PRODUCT

CHANGE NOTIFICATION

EE Series Photomicrosensor Packaging Change

EE SERIES PHOTOMICROSENSOR PACKAGE CHANGE

Changes:

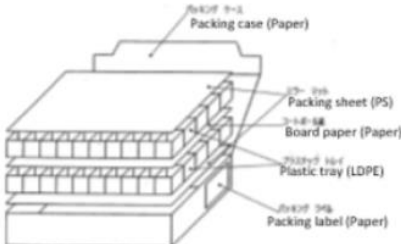
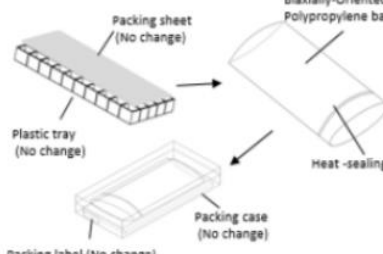
Effective at the end of March 2024, the listed photomicrosensors will begin to be shipped with heat-sealed inner bags. As such, the inner packaging style and packaging quantities for the listed sensors will change. **Only the EE-SX1041 will have a reduction to the Standard Pack and Master Pack quantities, for ordering purposes. The ordering quantities for all other listed sensors will remain the same.** (This notification only affects the sensors that are included within the notification.) The following details will fully explain the change and the part numbers affected. Should you have any additional questions, please communicate with your local OMRON Sales Professional.

Before the change	After the change																																																																								
Packing: EE-SX1041 Four polyethylene bags containing the sensor are packed in a packing case.  <table border="1"> <thead> <tr> <th>Model</th><th>QTY</th></tr> </thead> <tbody> <tr> <td>EE-SX1041</td><td>2000</td></tr> </tbody> </table>	Model	QTY	EE-SX1041	2000	Packing: EE-SX1041 A Biaxially-Oriented Polypropylene bag containing the sensor is thermally sealed. Pack 4 heat-sealed bags in a packing case.  <table border="1"> <thead> <tr> <th>Model</th><th>QTY</th></tr> </thead> <tbody> <tr> <td>EE-SX1041</td><td>1600</td></tr> </tbody> </table>	Model	QTY	EE-SX1041	1600																																																																
Model	QTY																																																																								
EE-SX1041	2000

Model	QTY																																																																								
EE-SX1041	1600																																																																								
Packing: EE Series Two plastic trays containing the sensor are packed in a packing case.  <table border="1"> <thead> <tr> <th>Model</th><th>QTY</th></tr> </thead> <tbody> <tr><td>EE-SJ8-B</td><td>200</td></tr> <tr><td>EE-SV3</td><td>100</td></tr> <tr><td>EE-SV3-B</td><td>100</td></tr> <tr><td>EE-SV3-C</td><td>100</td></tr> <tr><td>EE-SV3-CS</td><td>100</td></tr> <tr><td>EE-SV3-D</td><td>100</td></tr> <tr><td>EE-SV3-D5</td><td>100</td></tr> <tr><td>EE-SV3-G</td><td>100</td></tr> <tr><td>EE-SV3-G5</td><td>100</td></tr> <tr><td>EE-SX1018</td><td>200</td></tr> <tr><td>EE-SX1031</td><td>100</td></tr> <tr><td>EE-SX1042</td><td>200</td></tr> <tr><td>EE-SX1140</td><td>100</td></tr> <tr><td>EE-SX138</td><td>100</td></tr> <tr><td>EE-SX153</td><td>200</td></tr> <tr><td>EE-SY310</td><td>500</td></tr> <tr><td>EE-SY410</td><td>500</td></tr> </tbody> </table>	Model	QTY	EE-SJ8-B	200	EE-SV3	100	EE-SV3-B	100	EE-SV3-C	100	EE-SV3-CS	100	EE-SV3-D	100	EE-SV3-D5	100	EE-SV3-G	100	EE-SV3-G5	100	EE-SX1018	200	EE-SX1031	100	EE-SX1042	200	EE-SX1140	100	EE-SX138	100	EE-SX153	200	EE-SY310	500	EE-SY410	500	Packing: EE Series Plastic tray containing the sensor is placed in a Biaxially-Oriented Polypropylene bag and heat-sealed. One layer of plastic trays heat-sealed with bags is packed in a packing case.  <table border="1"> <thead> <tr> <th>Model</th><th>QTY</th></tr> </thead> <tbody> <tr><td>EE-SJ8-B</td><td>100</td></tr> <tr><td>EE-SV3</td><td>50</td></tr> <tr><td>EE-SV3-B</td><td>50</td></tr> <tr><td>EE-SV3-C</td><td>50</td></tr> <tr><td>EE-SV3-CS</td><td>50</td></tr> <tr><td>EE-SV3-D</td><td>50</td></tr> <tr><td>EE-SV3-D5</td><td>50</td></tr> <tr><td>EE-SV3-G</td><td>50</td></tr> <tr><td>EE-SV3-G5</td><td>50</td></tr> <tr><td>EE-SX1018</td><td>100</td></tr> <tr><td>EE-SX1031</td><td>50</td></tr> <tr><td>EE-SX1042</td><td>100</td></tr> <tr><td>EE-SX1140</td><td>50</td></tr> <tr><td>EE-SX138</td><td>50</td></tr> <tr><td>EE-SX153</td><td>100</td></tr> <tr><td>EE-SY310</td><td>250</td></tr> <tr><td>EE-SY410</td><td>250</td></tr> </tbody> </table>	Model	QTY	EE-SJ8-B	100	EE-SV3	50	EE-SV3-B	50	EE-SV3-C	50	EE-SV3-CS	50	EE-SV3-D	50	EE-SV3-D5	50	EE-SV3-G	50	EE-SV3-G5	50	EE-SX1018	100	EE-SX1031	50	EE-SX1042	100	EE-SX1140	50	EE-SX138	50	EE-SX153	100	EE-SY310	250	EE-SY410	250

Model	From	To
EE-SX1041	Standard Pack = 500 Master Pack = 2,000	Standard Pack = 400 Master Pack = 1,600

Models	Previous Packaging Qty (Standard Pack will remain this value)	New Qty
EE-SJ8-B	200	100
EE-SV3	100	50
EE-SV3-B	100	50
EE-SV3-C	100	50
EE-SV3-CS	100	50
EE-SV3-D	100	50
EE-SV3-DS	100	50
EE-SV3-G	100	50
EE-SV3-GS	100	50
EE-SX1018	200	100
EE-SX1031	100	50
EE-SX1042	200	100
EE-SX1140	100	50
EE-SX138	100	50
EE-SX153	200	100
EE-SY310	500	250
EE-SY410	500	250
